Access Compliance Report

Public Rights-of-Way

(Curb Ramps)

Intersection ID: 10570	Main Street: HERRIN_AV	Cross Street: HOLT_ST	Location: NE
ADA ID: E3141FDDBE37	Ramp Type: Perp	Initial Pass/Fail: Fail	Overall Compliance: No
Severity Score: 8.75			
Codes/Mitigation Info/Possible Solution		Field Measurements/Component Compliance

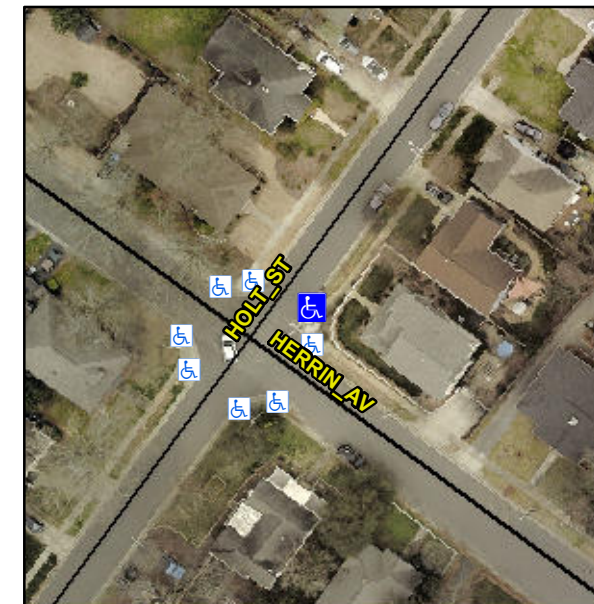
Not Found, R304.5.1

Compliance	Description	Data	Compliance	Description	Data
N/A	Ramp Length (in)	36.5	Yes	Ramp Slope (%)	5.0
No	Ramp Width (in)	46.0	Yes	Ramp XSlope (%)	0.8
N/A	Flare Type LT	N/A	N/A	Flare Type RT	N/A
N/A	Flare Slope LT (%)	N/A	N/A	Flare Slope RT (%)	N/A
N/A	Flare Traversable LT?	N/A	N/A	Flare Traversable RT?	N/A
N/A	Landing Length (in)	N/A	N/A	DWS Provided?	N/A
N/A	Landing Width (in)	N/A	N/A	DWS Contrast?	N/A
N/A	Landing Slope (%)	N/A	N/A	DWS Length (in)	N/A
N/A	Landing X Slope (%)	N/A	N/A	DWS Full Width?	N/A
N/A	Landing Curb? (Y/N)	N/A	N/A	DWS Offset (in)	N/A
N/A	Shared Landing?	N/A			
N/A	Gutter Ponding?	N/A	N/A	Gutter Slope (%)	N/A
N/A	Gutter Lip Ht (in)	N/A	N/A	Gutter X Slope (%)	N/A
N/A	Painted X Walk1?	No	N/A	Painted X Walk2?	N/A
	X Walk 1 Direction	To NW		X Walk 2 Direction	N/A
N/A	X Walk 1 Width (in)	N/A	N/A	X Walk 2 Width (in)	N/A
	X Walk 1 Slope (%)	0.2		X Walk 2 Slope (%)	N/A
	X Walk 1 X Slope (%)	2.5		X Walk 2 X Slope (%)	N/A

Remove & Replace Entire Ramp.
